Revisions
Bubbled areas indicate revisions compared to the previously submitted plans
Received Date
November 30, 2020

SCHOOL DISTRICT 61
VIC HIGH SCHOOL

Sheet Name
Variance Submission for City - Site Plan - Existing

Sheet Name
Variance Submission - Site Plan - New

1 VARIANCE SUBMISSION - LEVEL 0 (Basement)
A3.600 1:200

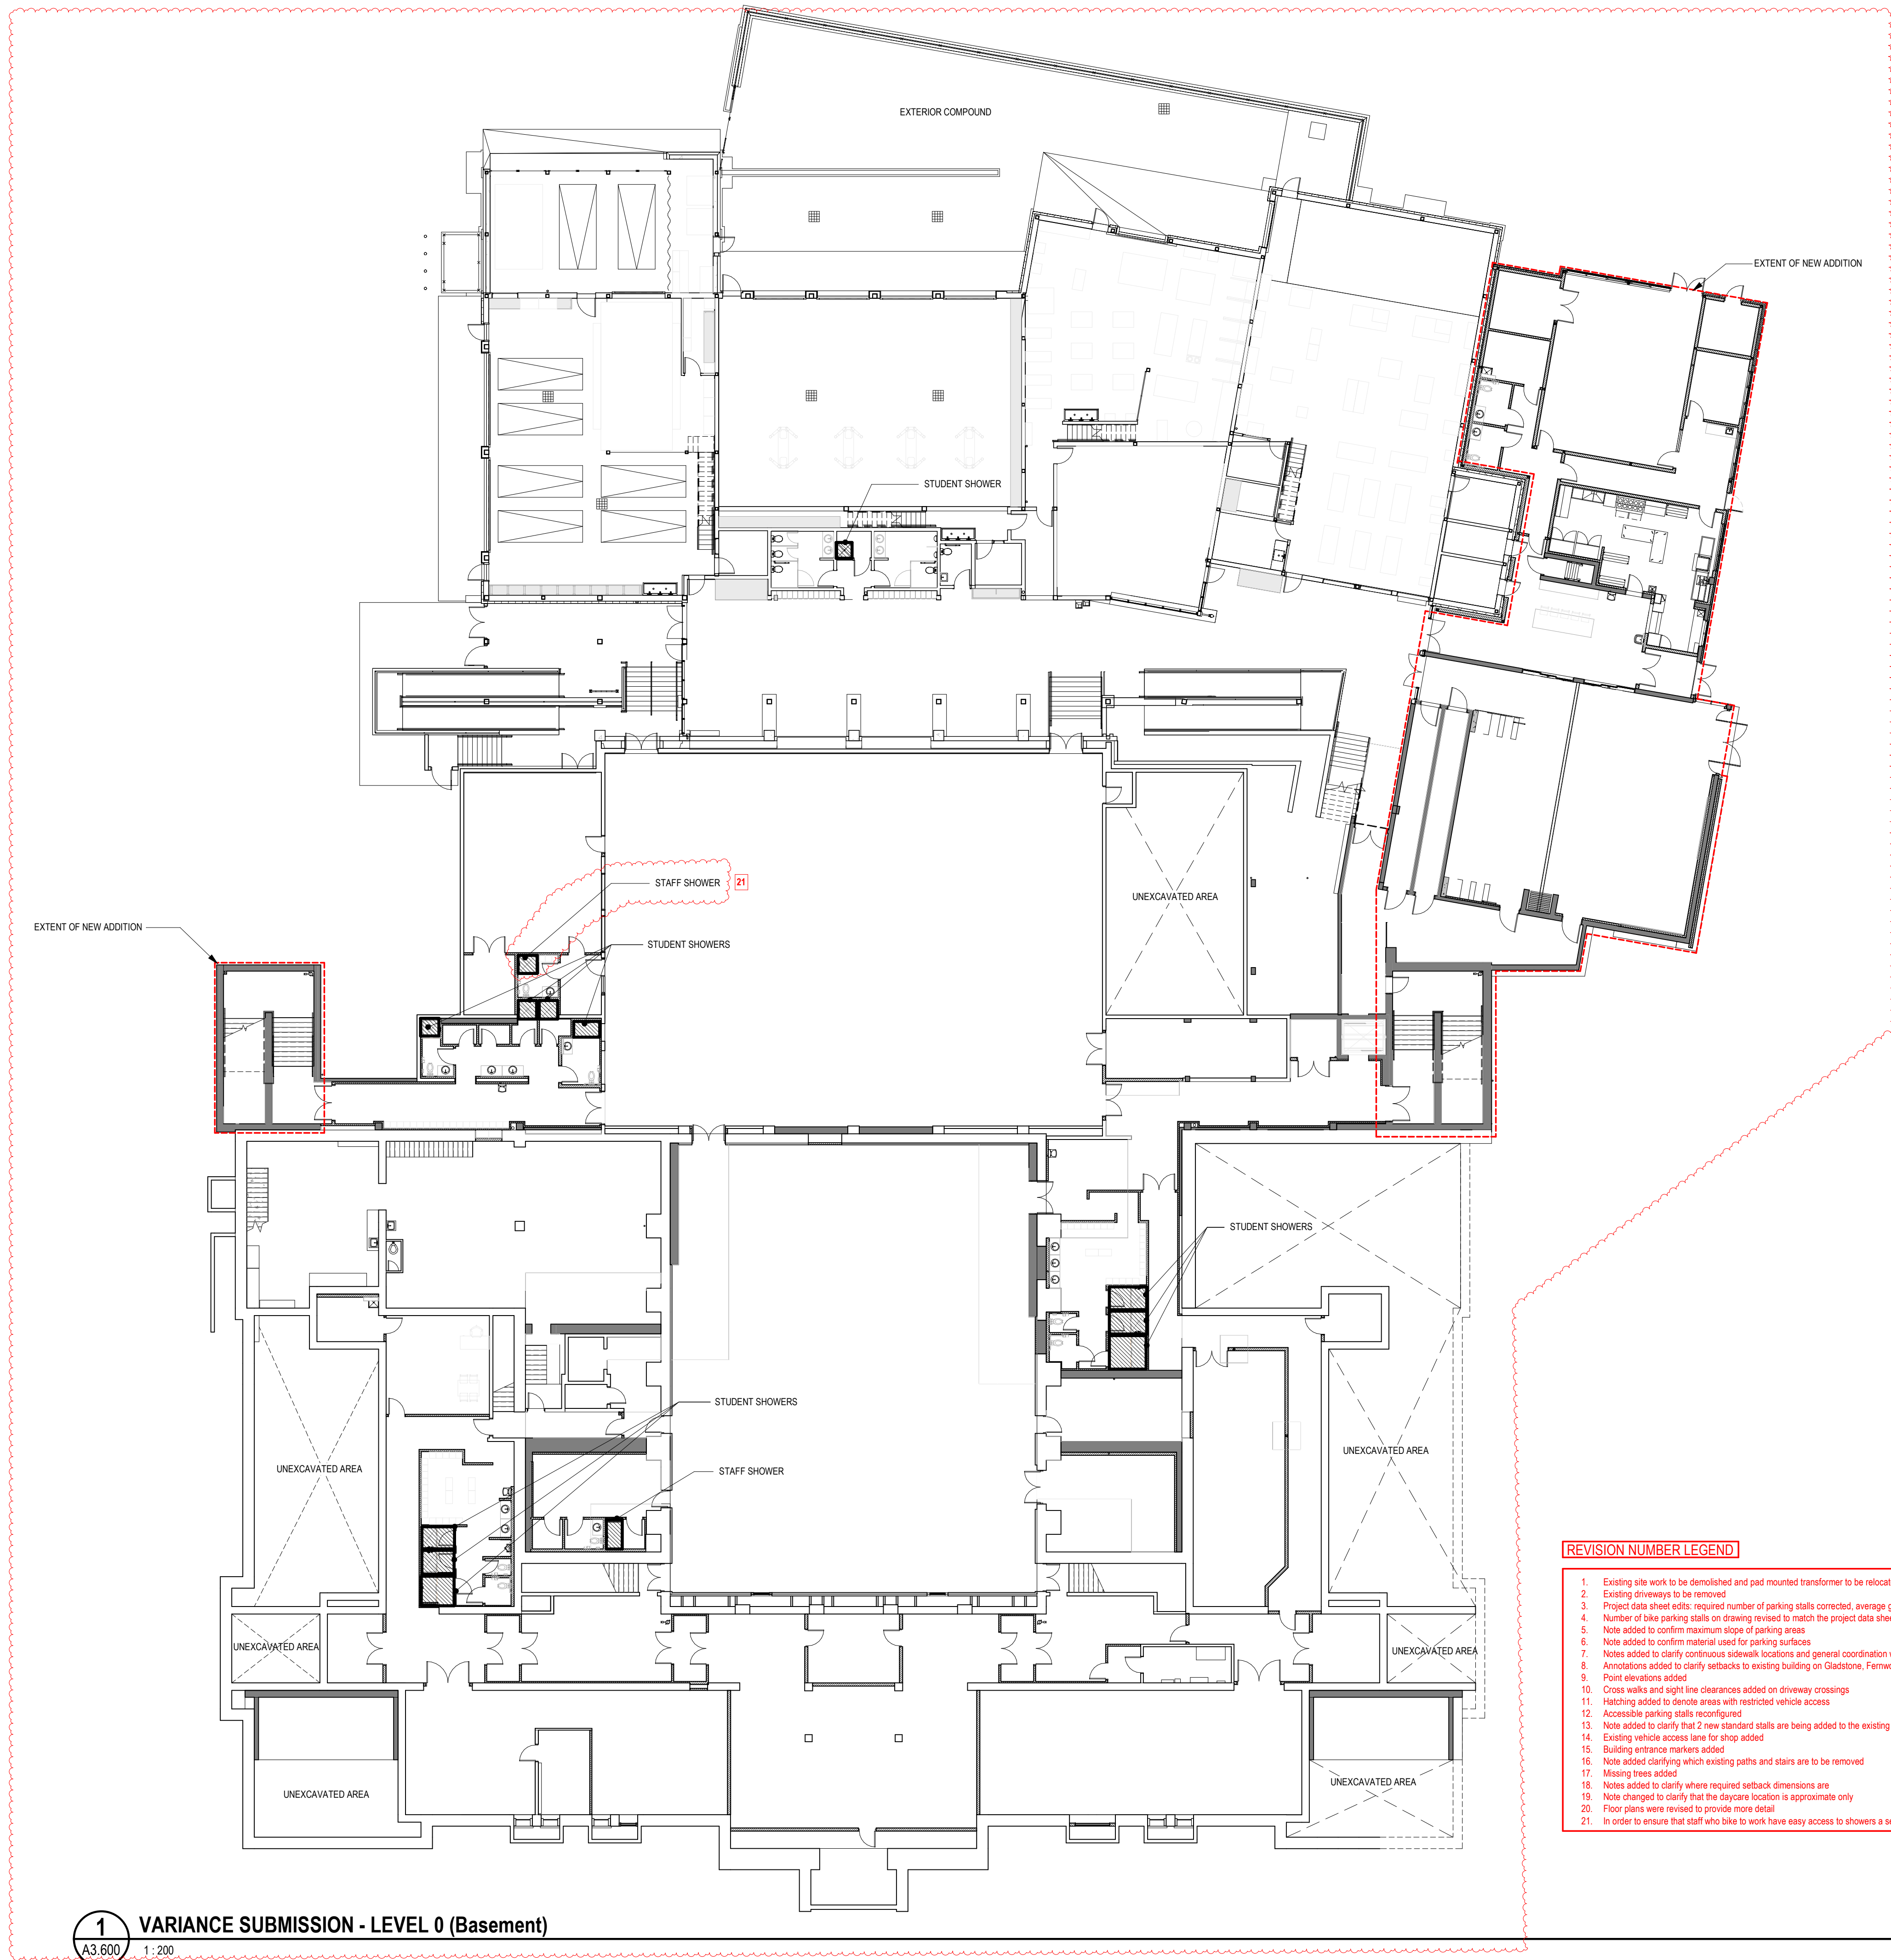
- Floor plans were revised to provide more detail
 - In order to ensure that staff who bike to work have easy access to showers a second staff shower was added, and the original one relocated to main floor

1 VARIANCE SUBMISSION - LEVEL 1 (Ground Floor)
A3.305 1:200

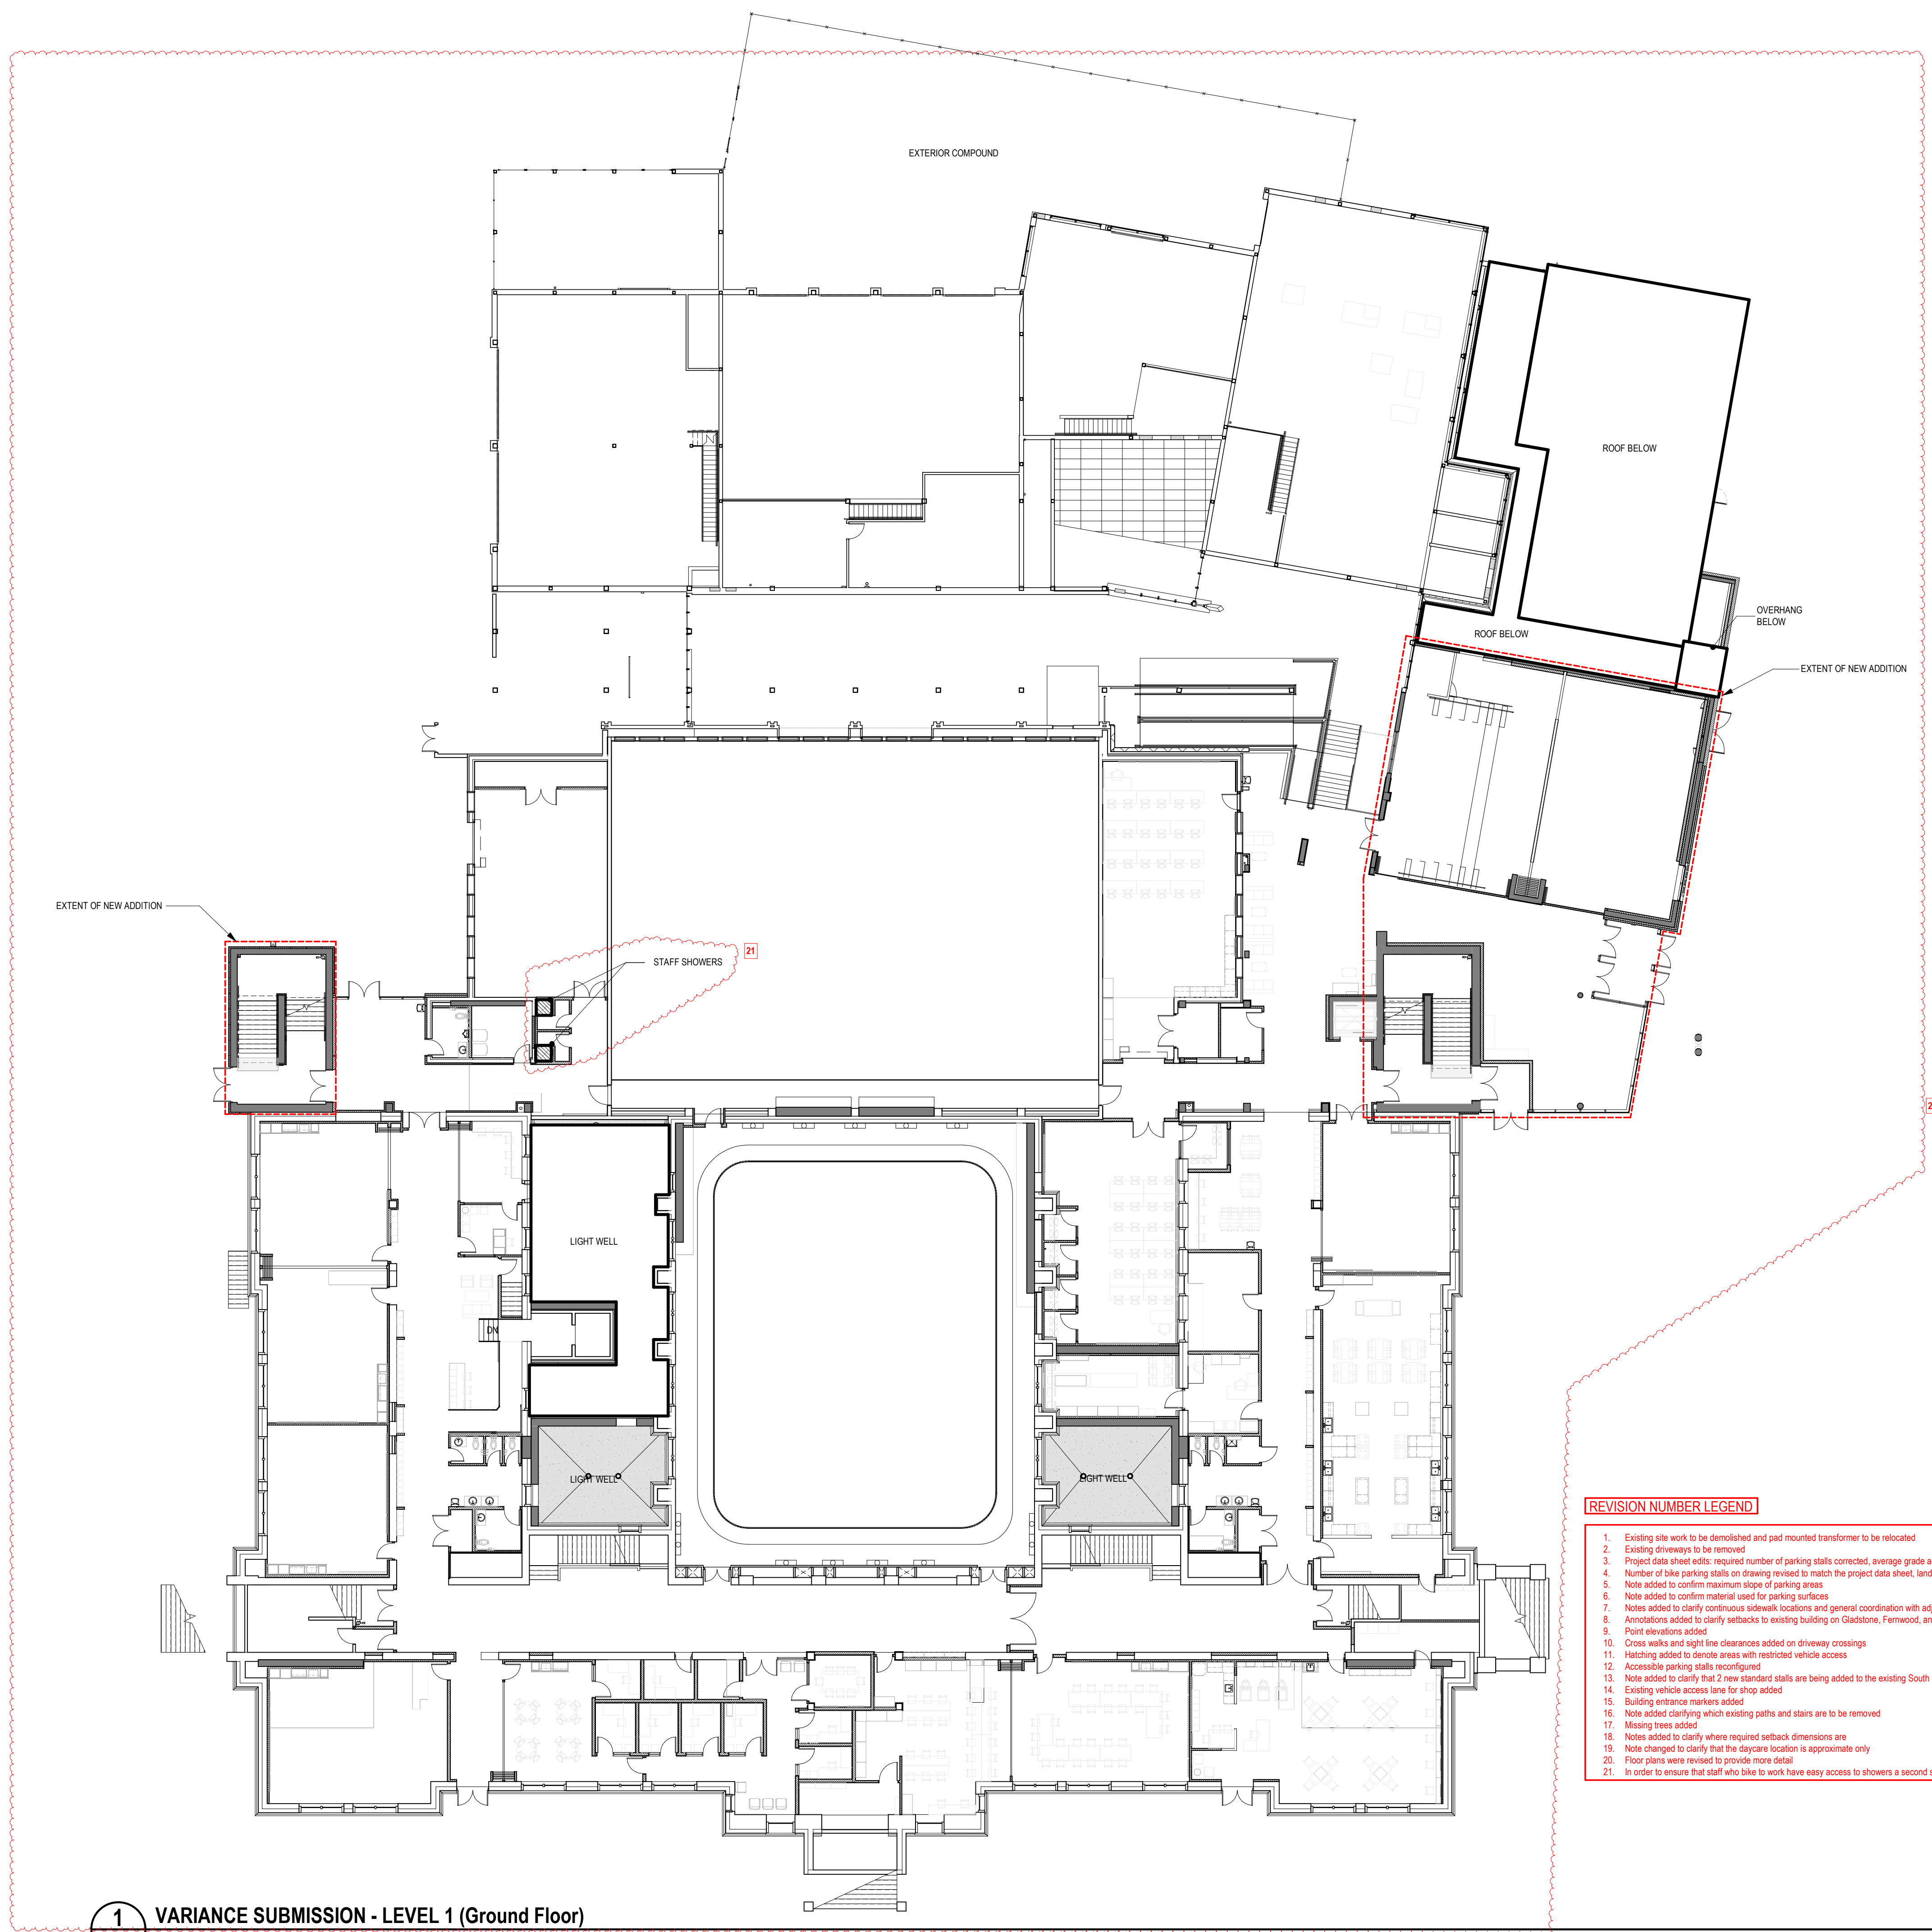
20. Floor plans were revised to provide more detail
 21. In order to ensure that staff who bike to work have easy access to showers a second staff shower was added, and the original one relocated to main floor
